Co3237 Poultney BF 0145(13)

ADDENDUM #1

- Invitation for Bids, and Proposal to extend Bid Opening to June 13, 2025, and update the Schedule of Items.
- Special Provision Pages 1 and 6.
- Plan sheets 3, 10, 11, 44-52, 57, 63, 65, 79-82, 93, 94, 96, and 97.
- New Impact Plans shall replace Pages 136 to 171 in the Proposal.

TRUSS TYPICAL SECTION

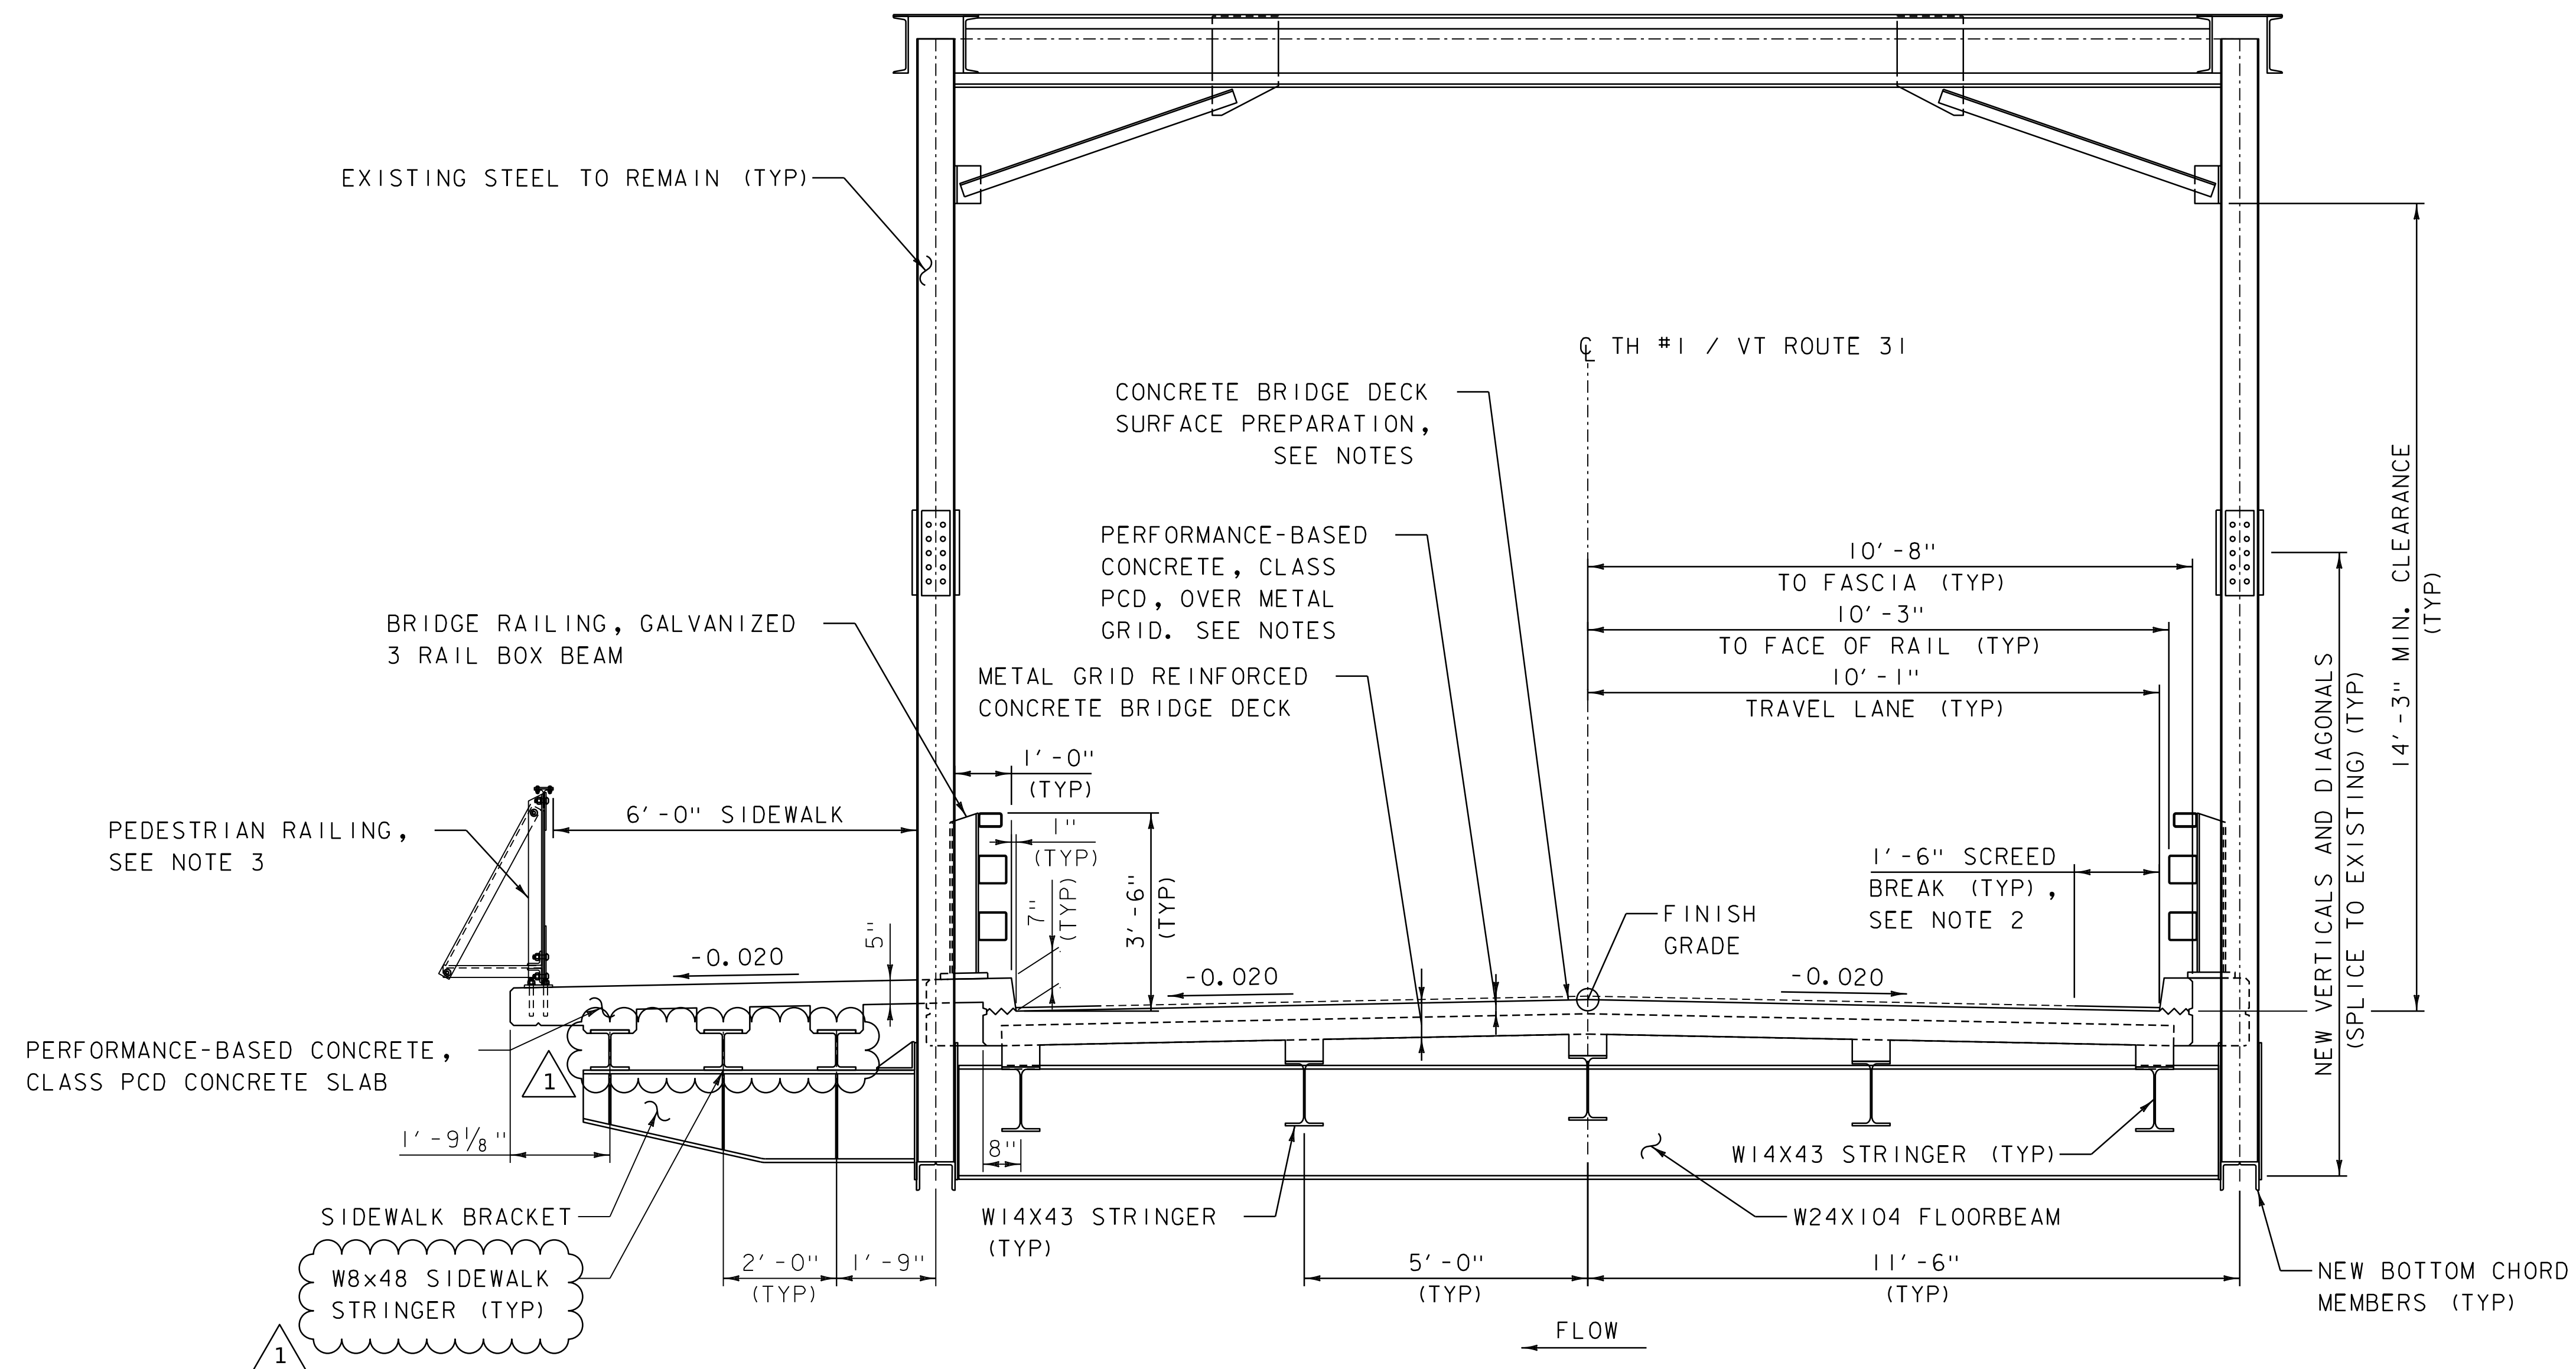
ADDENDUM	REVISION	PLOT DATE	DESCRIPTION	BY
1	1	19-MAY-2025	UPDATED SIDEWALK STRINGERS TO W8X48	MSWT

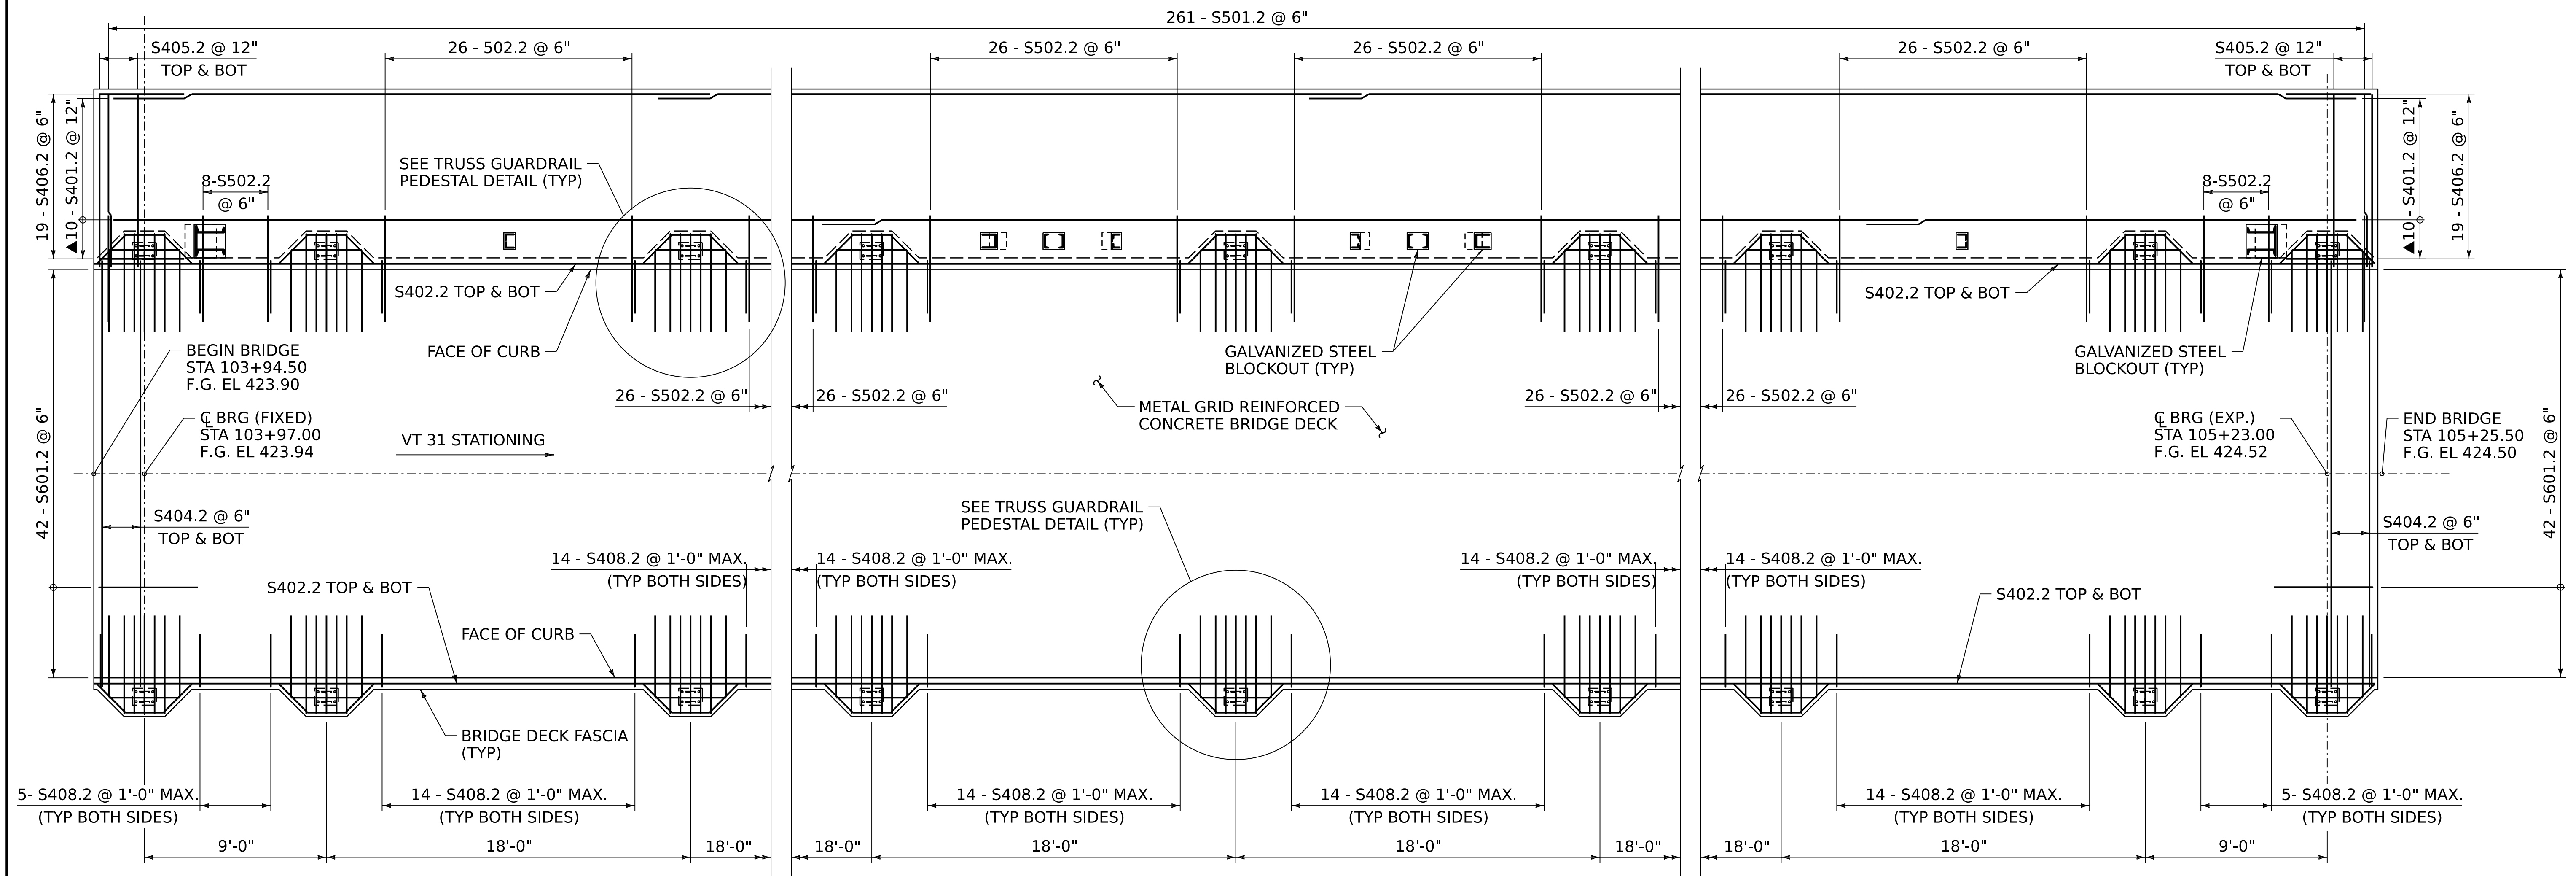
21						21		LF	JOINT SEALER, HOT POURED	524.1100									
						270						270		LF	BRIDGE RAILING, GALVANIZED 3 RAIL BOX BEAM	525.3130									
						132						132		LF	BRIDGE RAILING, METAL TRUSS BRIDGE	525.6100									
						1						1		LS	ONE LANE TEMPORARY BRIDGE (4800 SF - EST)	528.1000									
						1						1		EACH	PARTIAL REMOVAL OF STRUCTURE	529.2000									
						4						4		EACH	BEARING DEVICE ASSEMBLY, ELASTOMERIC PAD W/EXT. LOAD PLATES	531.1800									
										1300		1300		LF	MICROPILE, CASED	547.1000									
																		PROJECT NAME: POULTNEY PROJECT NUMBER: BF 0145(I3)							
																		FILE NAME: z2lj64qs.dgn PROJECT LEADER: J.D. KEENER DESIGNED BY: VHB QUANTITY SHEET (1 OF 3)				PLOT DATE: 5/19/2025 DRAWN BY: T.D. BURT CHECKED BY: J.D. KEENER SHEET II OF II5			
ADDENDUM	REVISION	PLOT DATE	DESCRIPTION		BY																				
1	1	5/19/2025	REVISED ITEM 506.5000 QUANTITY		NAT
